ENGINEERING CHANGE NOTICE

Page 1 of 91. ECN 169871Proj.
ECN

This change to the Site Characterization Work Plan - 200 Areas Treated Effluent Disposal Basin, Project W-049H addresses a field permeability test to be conducted at the site proposed for the W-049H Treated Effluent Disposal Facility. A field permeability test will be conducted at the candidate site to obtain water infiltration rates of insitu sediments at the site.

FIELD PERMEABILITY TEST PLAN
--W-049H 200 AREAS TREATED EFFLUENT DISPOSAL FACILITY--

Figure 1. Field Permeability Borehole and Trench Test Locations

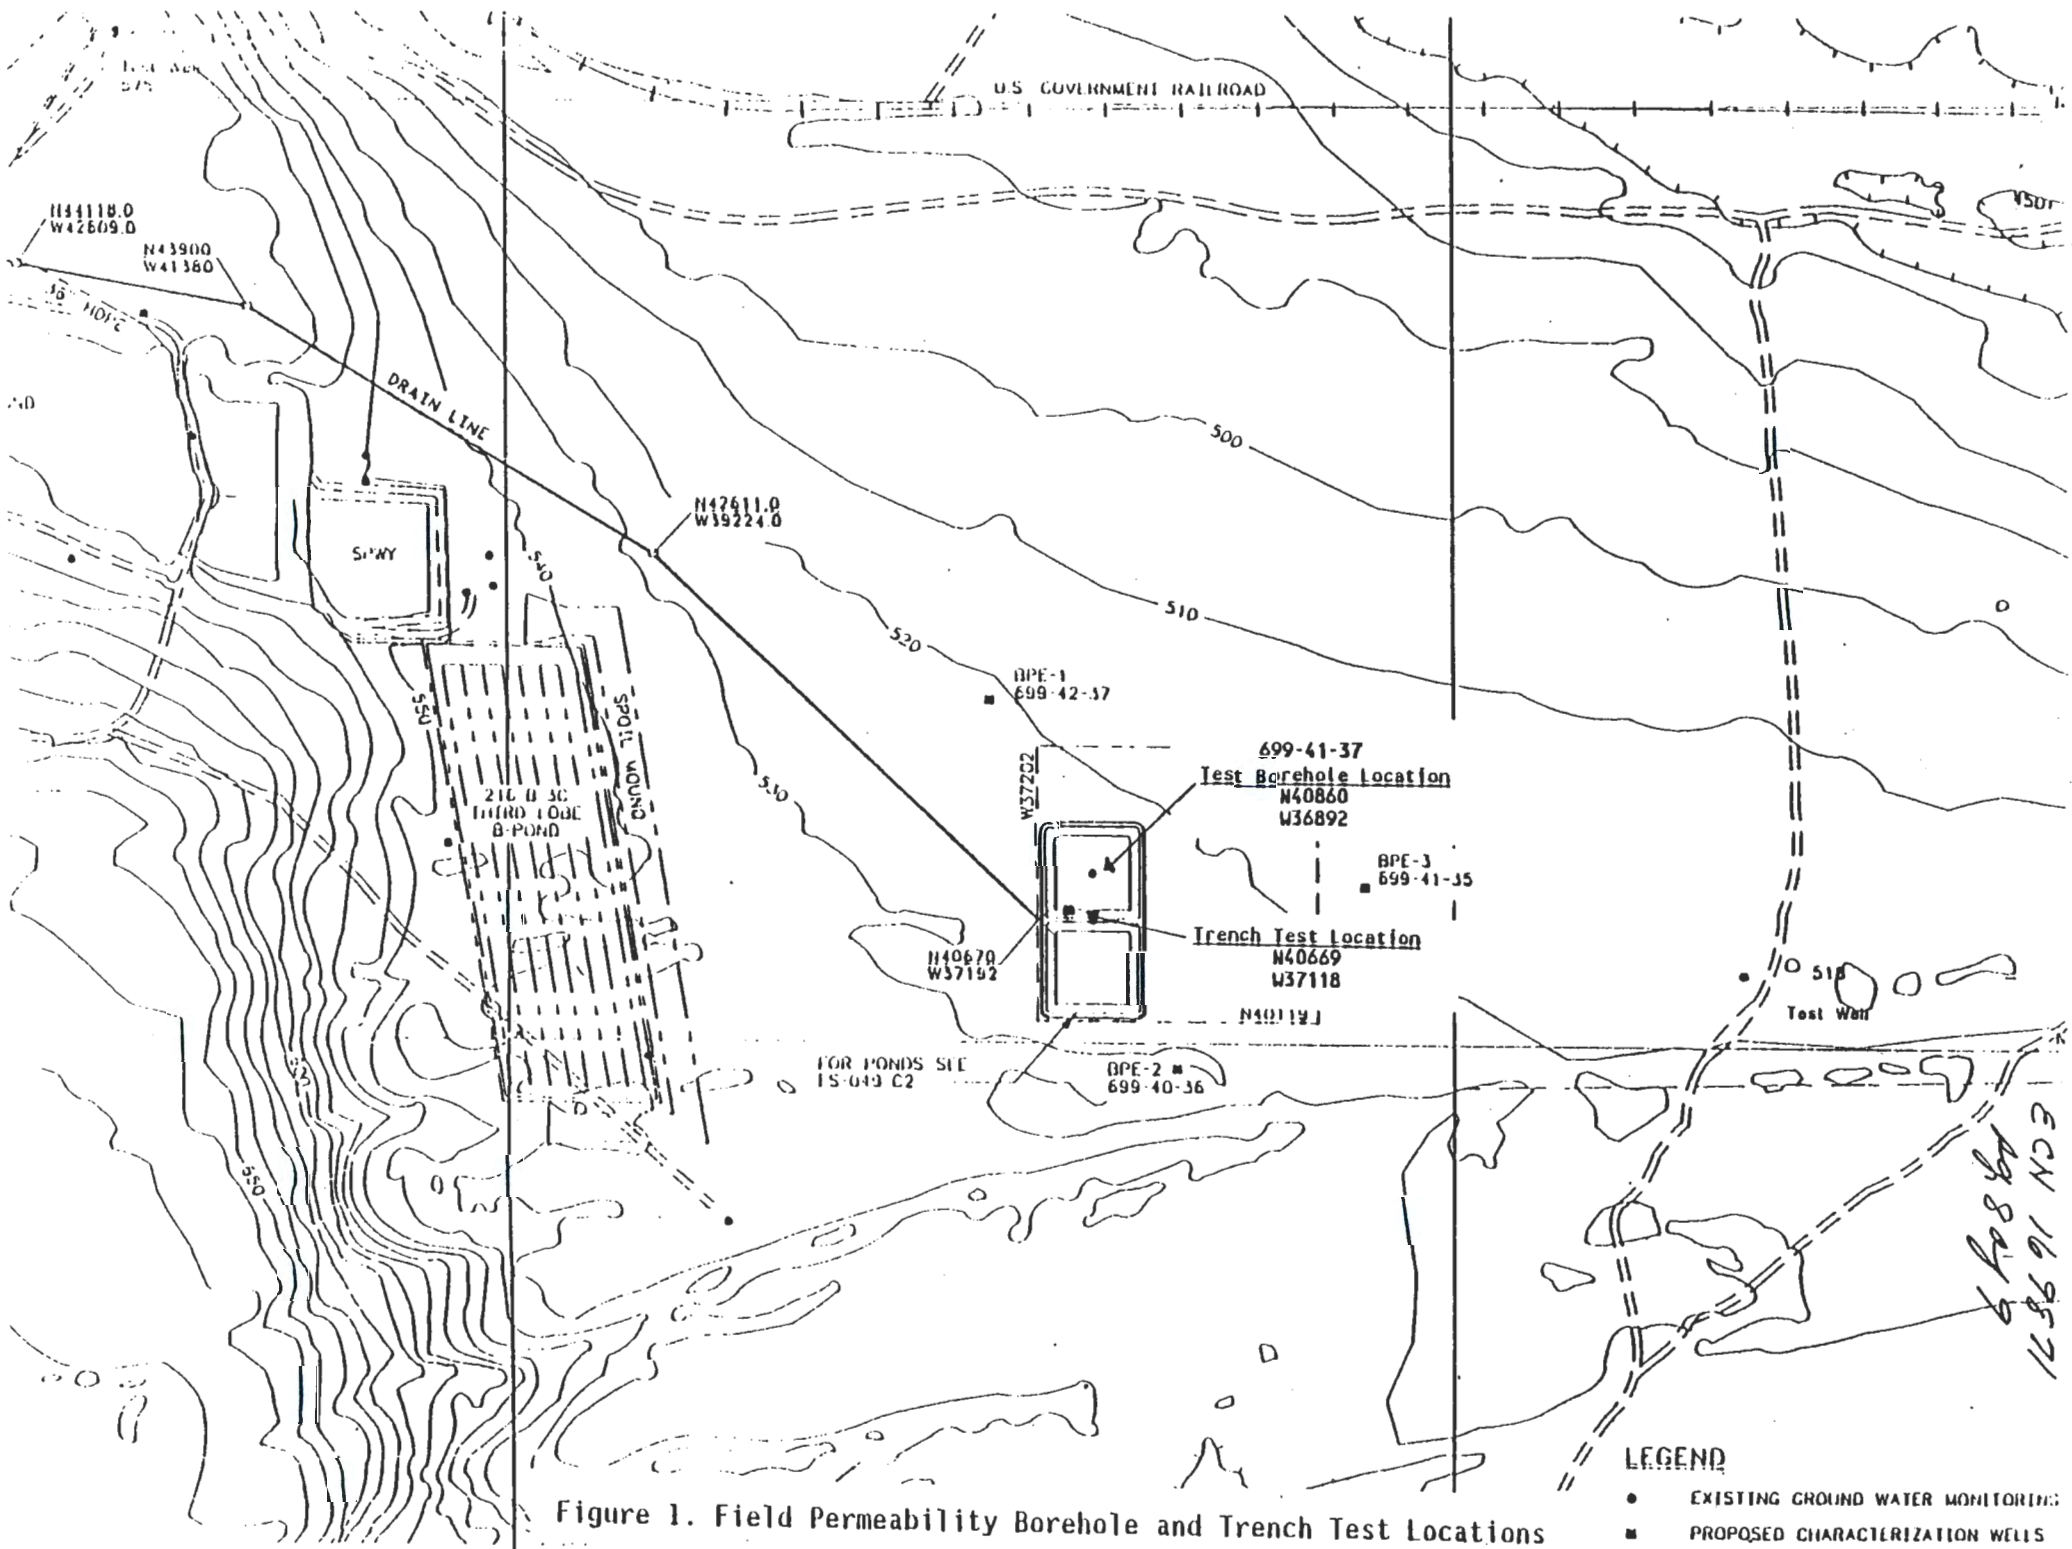
The objective of this test plan is to specify the design and implementation requirements for conducting a (1) shallow-well pump-in test in a borehole to be drilled within the envisioned perimeter of the treated effluent disposal pond and (2) a percolation test in a trench excavated by backhoe in the bottom of the access road borrow pit (Figure 1).

A trench is to be excavated by backhoe to a depth of 4' in the bottom of the borrow pit at coordinates N40669 and W37118. The length and width dimensions of the trench are not to exceed what is needed to obtain the specified depth, and ideally are not to exceed 4'x4'. After the trench has been excavated to the required depth, the trench walls are either to be lined with an impermeable material (i.e., plastic) or an appropriate length of culvert is to be set vertically in the trench and the trench backfilled around the culvert. Before the trench or culvert is filled with water, a pressure transducer, protected by a vertically emplaced, open PVC pipe is to be lowered to the bottom of the trench. The PVC pipe is to be held in place at the mouth of the opening by tying it to a plank or second section of PVC pipe placed horizontally across the width of the opening.

Figure 2. Equipment Set-up for Well Pump-In Test

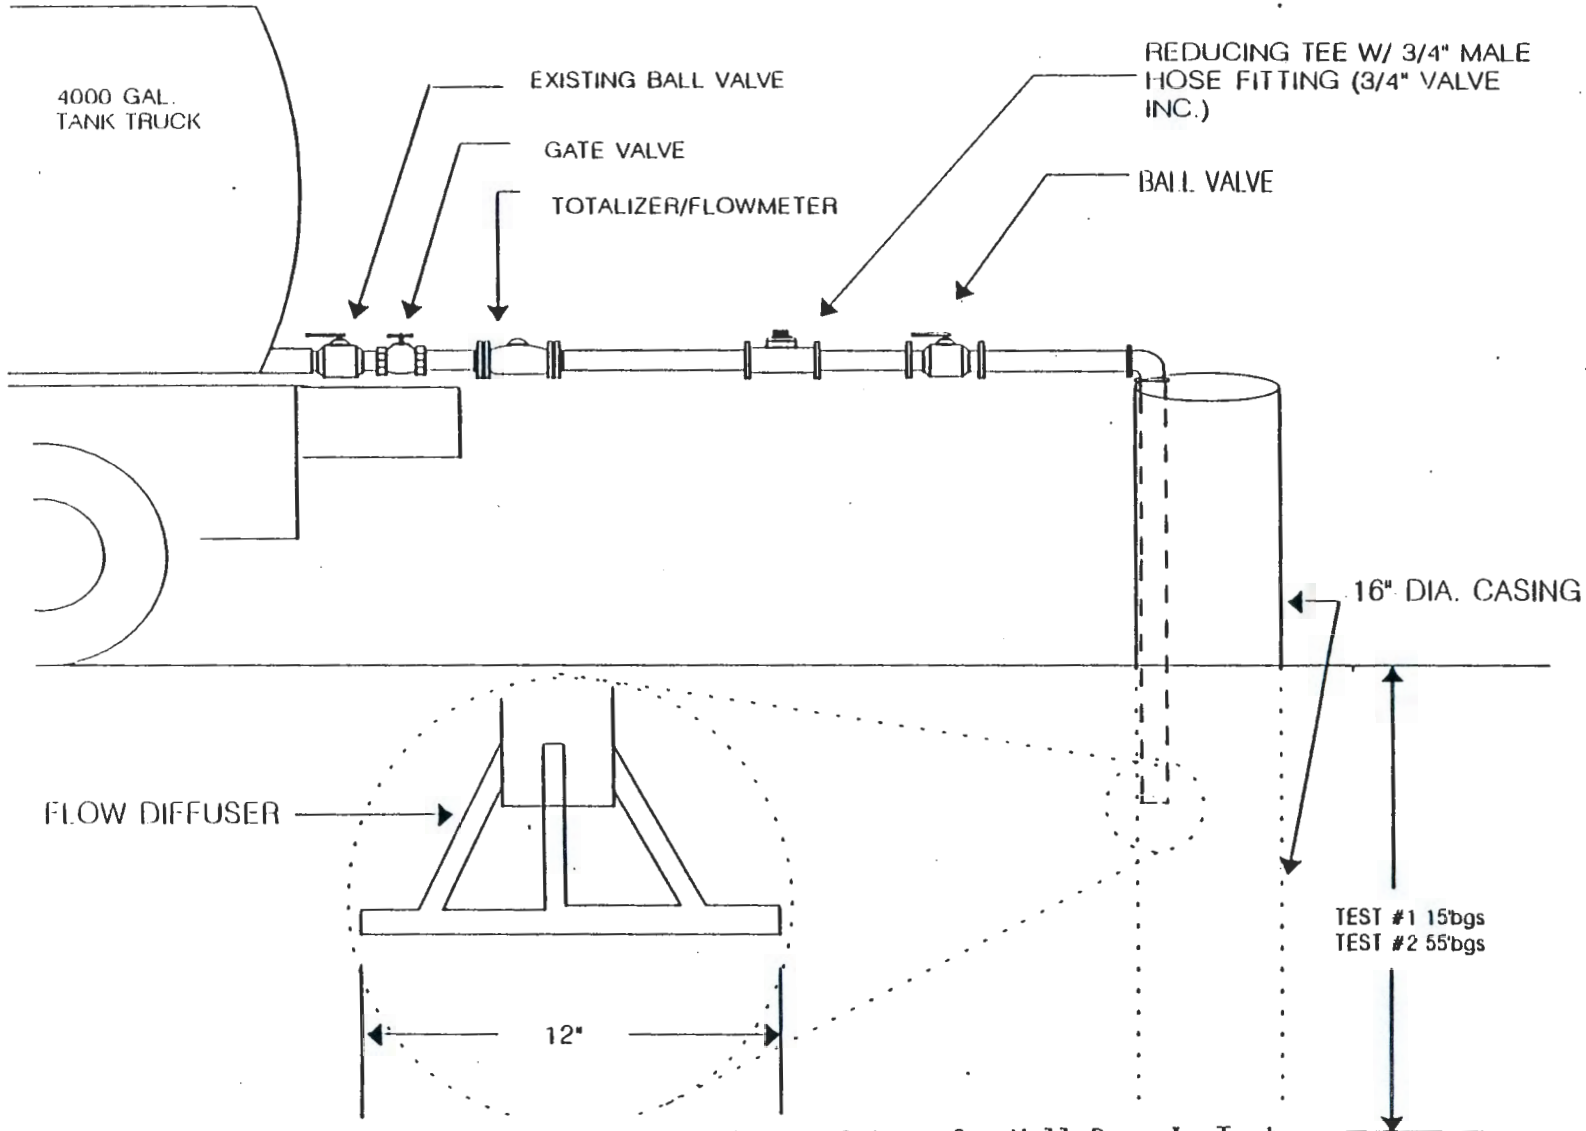
A constant head of 10'-14' is to be maintained within the casing and monitored by a pressure transducer installed in the borehole. Initially, the flow rate is expected to be relatively high (i.e., >10 gal/min), but should then become constant at a lower rate (e.g., 5 gal/min). Water may have to be added to the hole for a relatively long time (e.g., >4 hours) before Q approaches a constant value. Once the hydraulic head and flow rate have become constant, K_{sat} for the wetted zone can be calculated. After the test at a depth of 15' is successfully completed, the borehole is to be advanced and a second pump-in test performed at a depth of 55', where the Hanford formation has a higher silt content (Figure 2).
